ref:2016-0007-access1

Robbin Gibbon
FoodBoss Cold Storage
24-27 Lambridge Place,
Penrith NSW 2750

**Re: Proposed Alterations and Additions to 24- 27 Lambridge Place, Penrith
Disabled Access Capability Statement**

Figure 01 — Offset tread stairs within fire

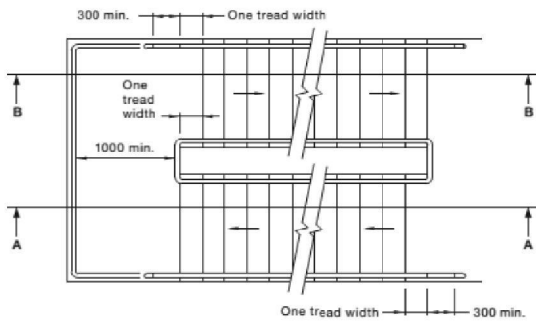
- (vi) A stairway must comply with clauses 11.1(f) and g) and handrails comply with clause 12 of AS1428.1-2009. This may require an offset tread (see Figure 01 below)

Figure 02 — handrail extensions

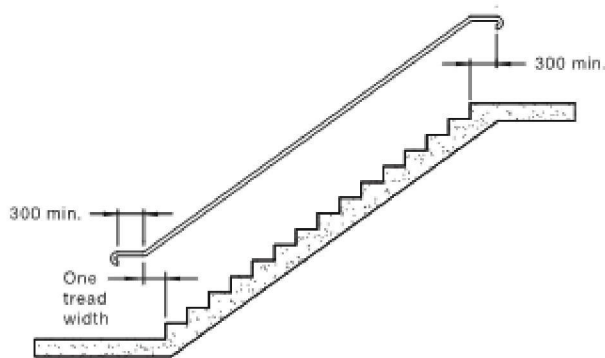
- (vii) Stairway handrails must be continuous throughout the stair flight and around landings and be provided on both sides of the stairway. Handrails must comply with Clause 11.2 of AS1428.1-2009 which requires a 300mm extension at both the top and bottom of the flight (see Figure 02 below).

Figure 03 — Accessible car parking spaces

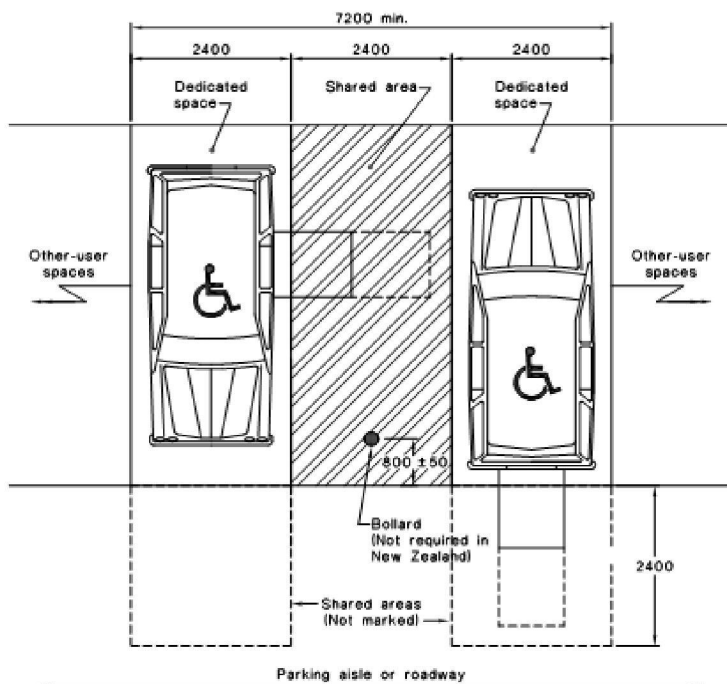
- (i) Not less than one (1) accessible parking bay with internal dimensions of 2400mm min. width x 5400mm min. length adjacent to shared zone with 2400mm min. width x 5400mm min. length with bollard installed at start of shared zone in accordance with AS2890.6, fig 2.2, 2.3; (see Figure 03 below).
- (ii) Need not be designated where there is a total of not more than 5 carparking spaces, so as to restrict the use of the car parking space only for people with a disability; and
- (i) Accessible car bays and associated shared zones to have a minimum vertical clearance no less than 2500mm. The vertical clearance leading to the accessible car bay may not be less than 2200mm.

Currently there is an existing accessible carparking space designated near the front entrance of the building. However, this carparking space is not correctly line marked and the adjacent space is not line marked as a dedicated shared space.

Therefore, to comply the designated accessible space and the adjacent share space will need to be line marked as outlined above and a bollard provided in the share space as required by AS2890.6
